**APPEAL STAFF REPORT
 SUBSTANTIAL ISSUE DETERMINATION**

Appeal Number: **A-3-STC-99-081, Neary Lagoon Skate Park**

Project Description: Construction of 14,600 square-foot Skate Park with adjoining non-skateable pathways, landscaping, viewing areas, fencing, and the addition of three parking spaces to an existing parking area.

Site Layout Plan for the Santa Cruz City Skatepark Facility at Neary Lagoon Park

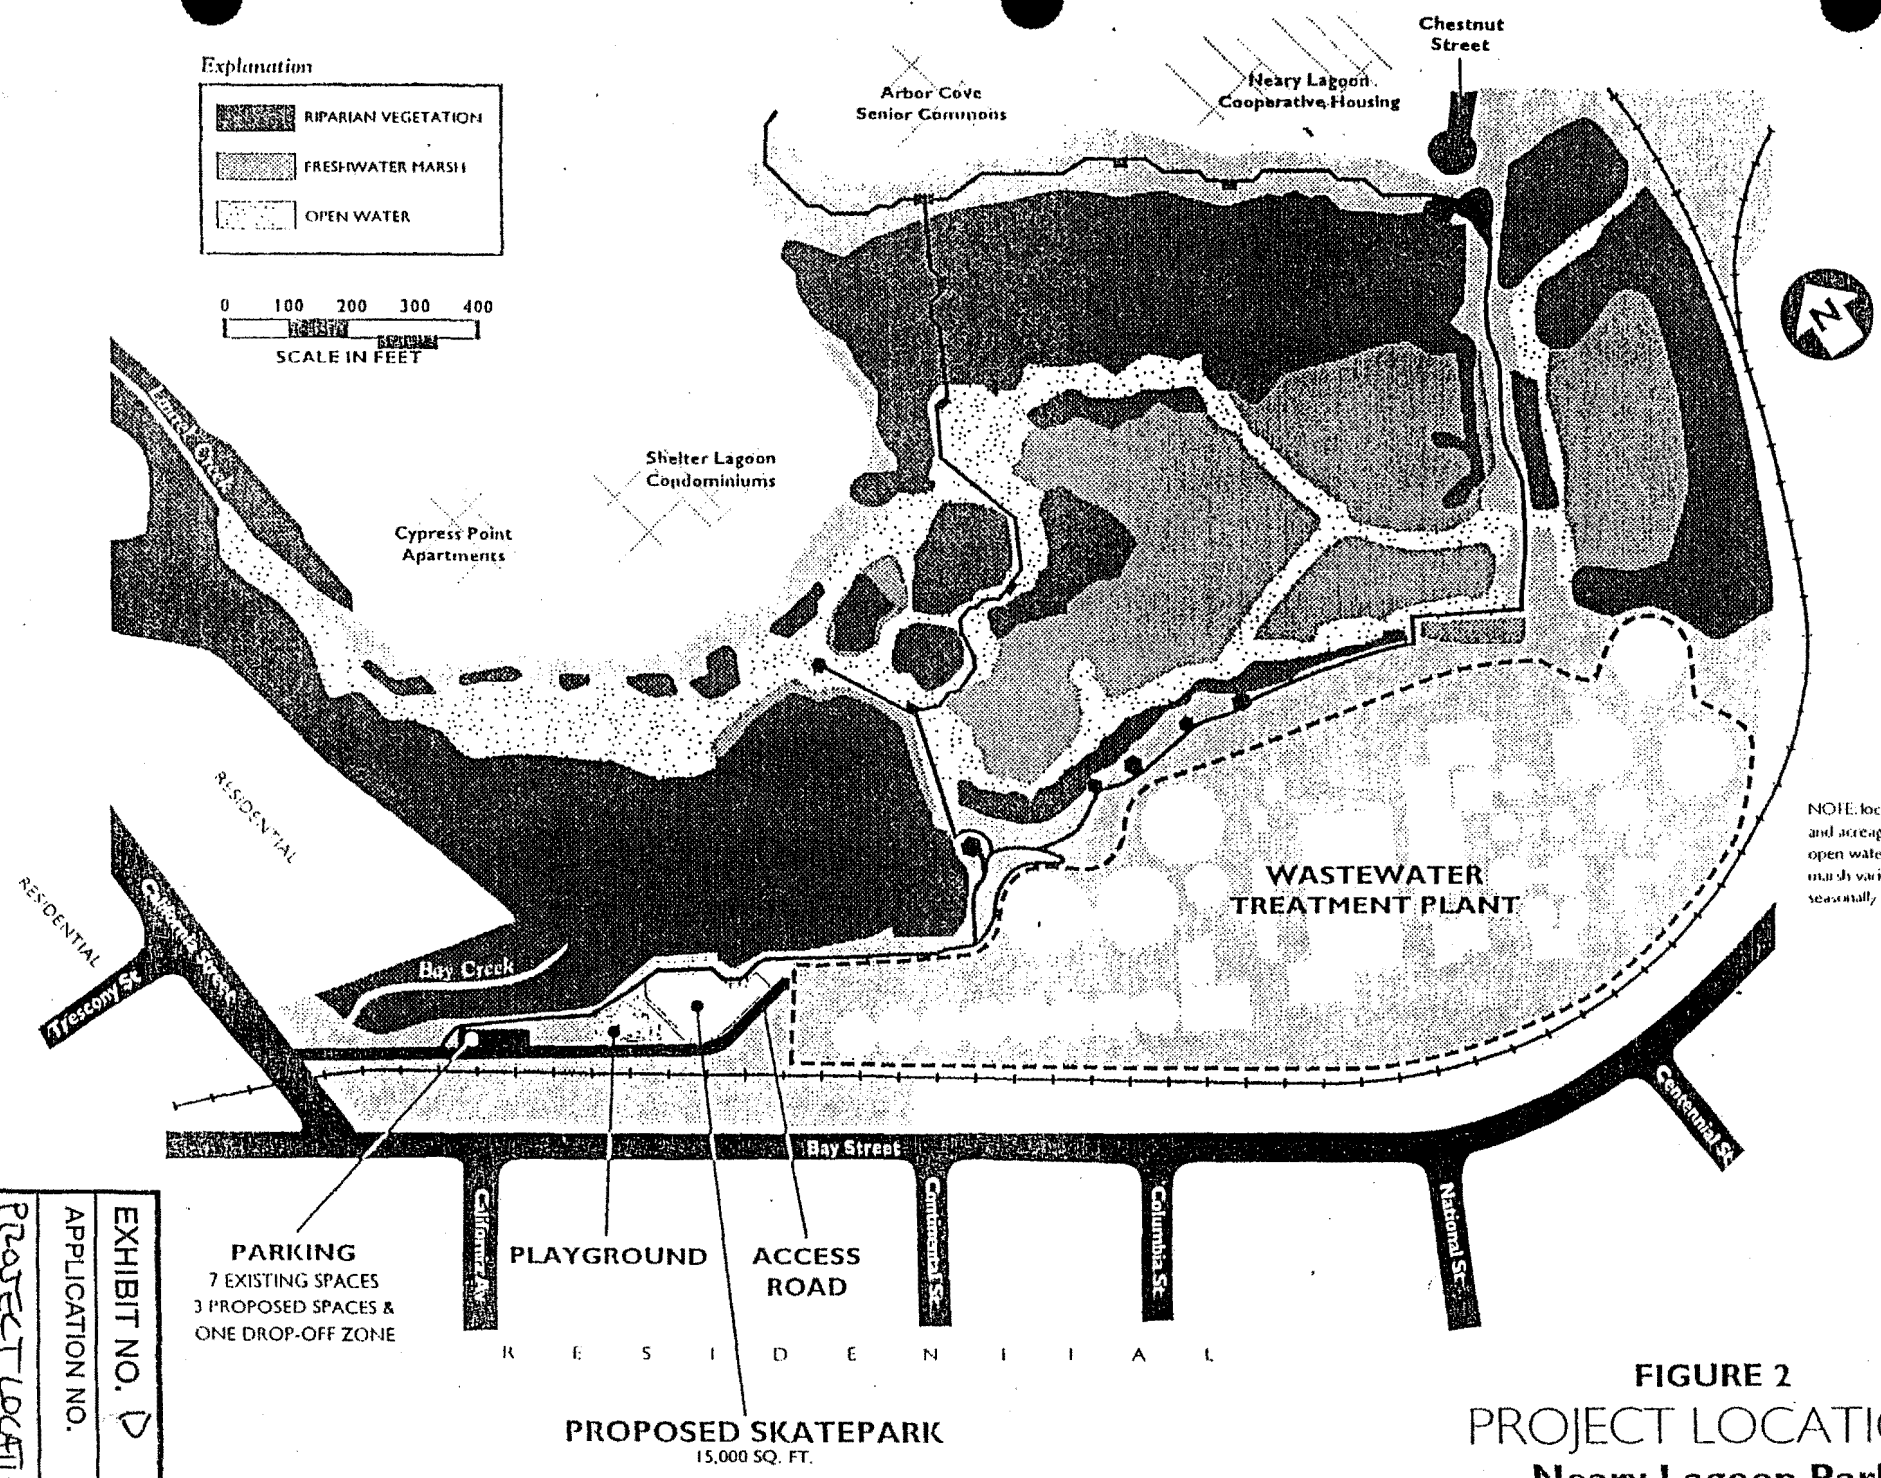
Automotive as well as pedestrian-oriented modes of travel would be able to access the Skate Park from either Bay or California Streets at the southwestern border of Neary Lagoon. Pedestrian access to the Skate Park from the greater downtown area of Santa Cruz is possible from Blackburn and Chestnut Streets at the northwestern border of Neary Lagoon. Access to the Skate Park from Blackburn and Chestnut Streets requires travel through Neary Lagoon. (See Exhibit A for project plans)

Neary Lagoon Management Area with Management Zones

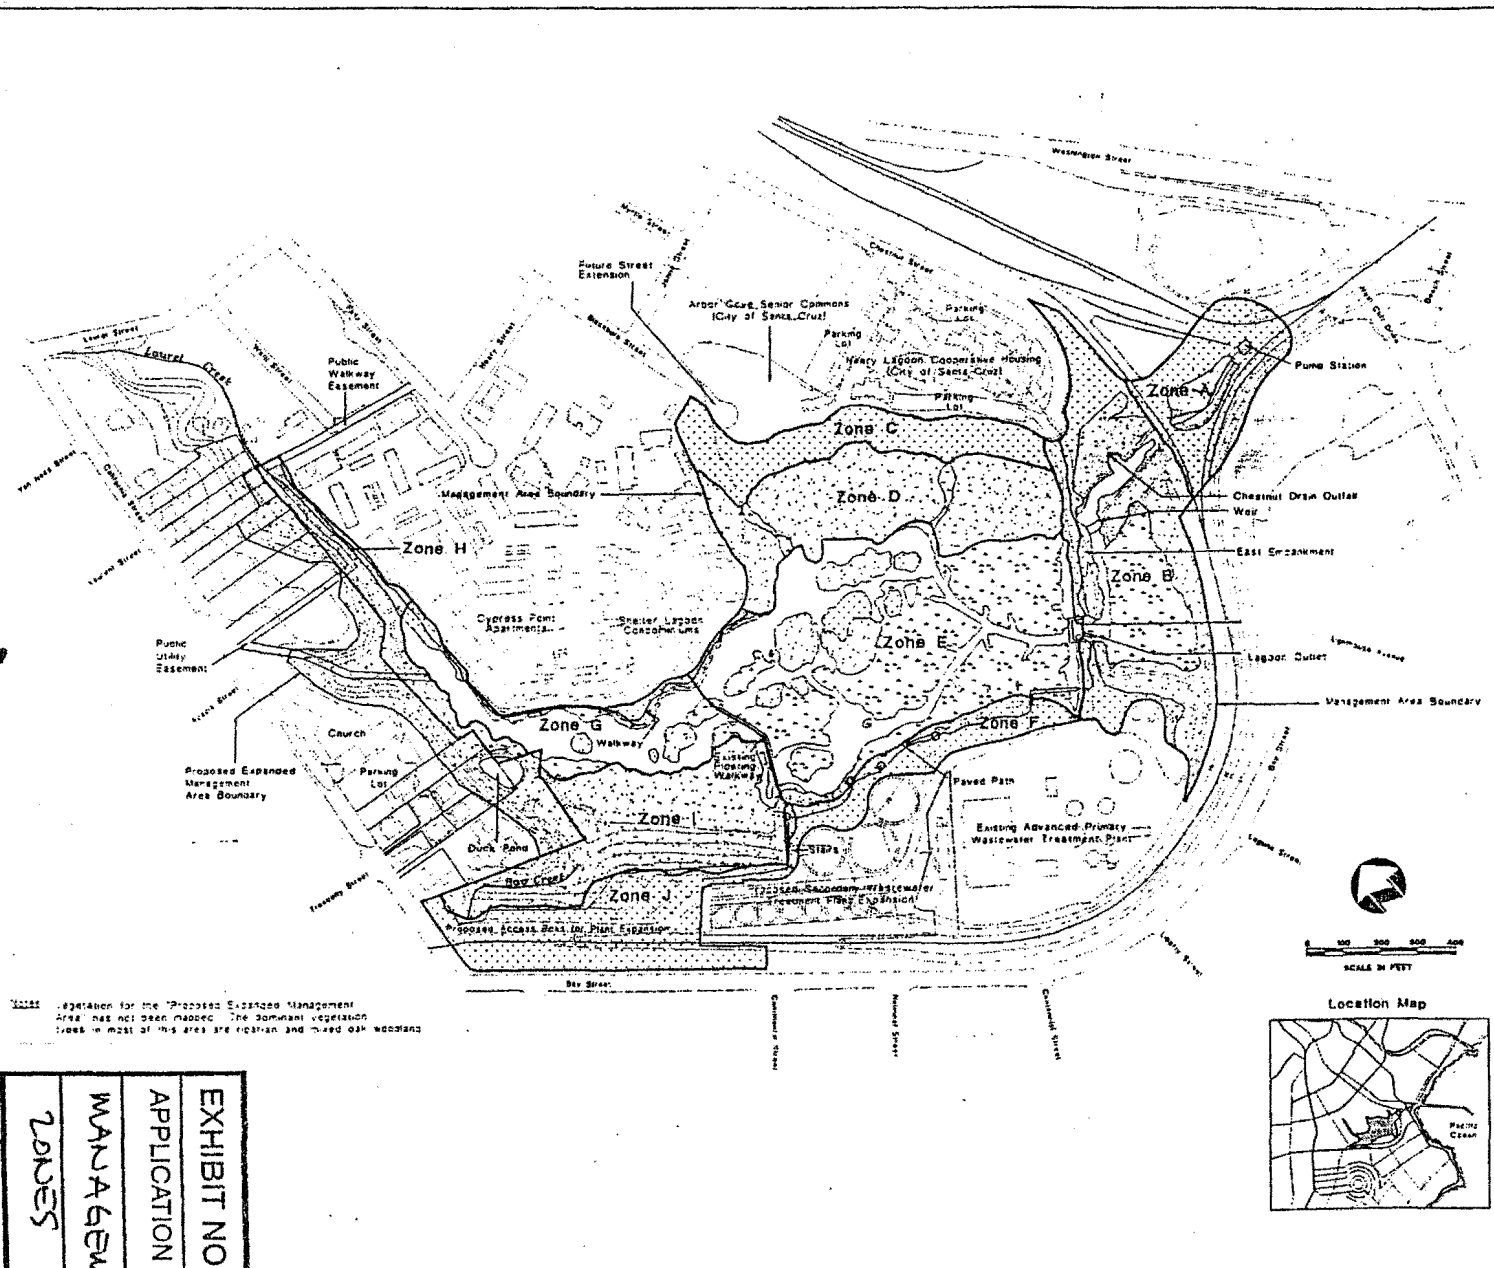
The Neary Lagoon Management Plan separates the lagoon into ten management zones (A through J). The proposed Skate Park occurs within management zone J. Fifteen of the management zones, or approximately 75% of the lagoon, are largely off limits to direct use and are designated as habitat, though pathways and boardwalks provide views to some of these areas. The five remaining management zones, including Zone J, are designated as maintained, recreation, grassland, and ruderal. (See Exhibit F for Management Zone Map)

FIGURE 1: NOISE MEASUREMENT LOCATIONS

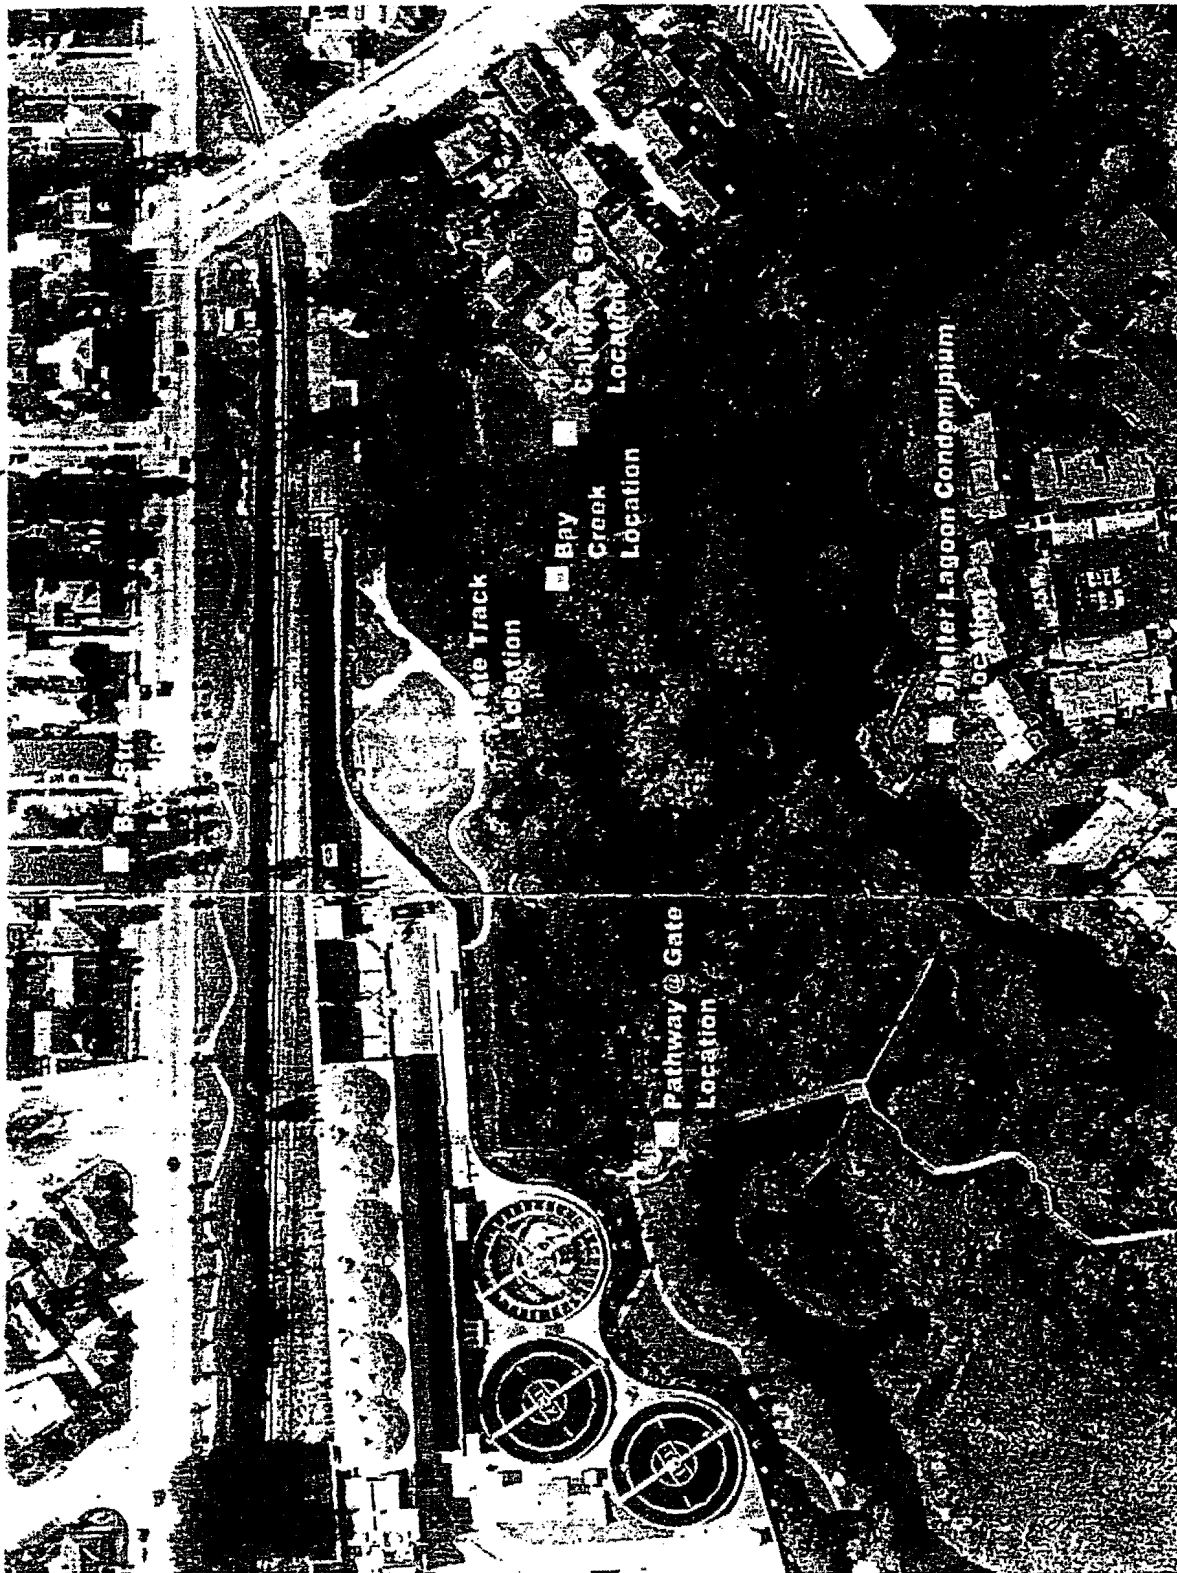
However, the FEIR did not include any acoustical analysis of the riparian corridor or natural areas of Neary Lagoon to support this conclusion. In fact, previous acoustical analysis completed for the project only addressed the potential impacts of the Skate Park to nearby residential neighborhoods. The FEIR also did not provide any discussion of the methodology of sampling and data extrapolation used to estimate the expected noise levels.

According to the technical memorandum, "*Skateboard Noise Characterization at Santa Rosa Skate Park*," dated November 23, 1999, predicted noise levels were obtained by sampling at the Santa Rosa Skate Park on Monday, 1 September 1997, which was the Labor Day Holiday (See Exhibit J). The memorandum provides a complete explanation of the sampling methodology and site characteristics. The memorandum states that, "the number of users within the fenced perimeter of the skate track did not exceed approximately 15-20 at any time during the survey period." Furthermore, sound measurement sampling was done for a period of approximately sixty-three minutes.
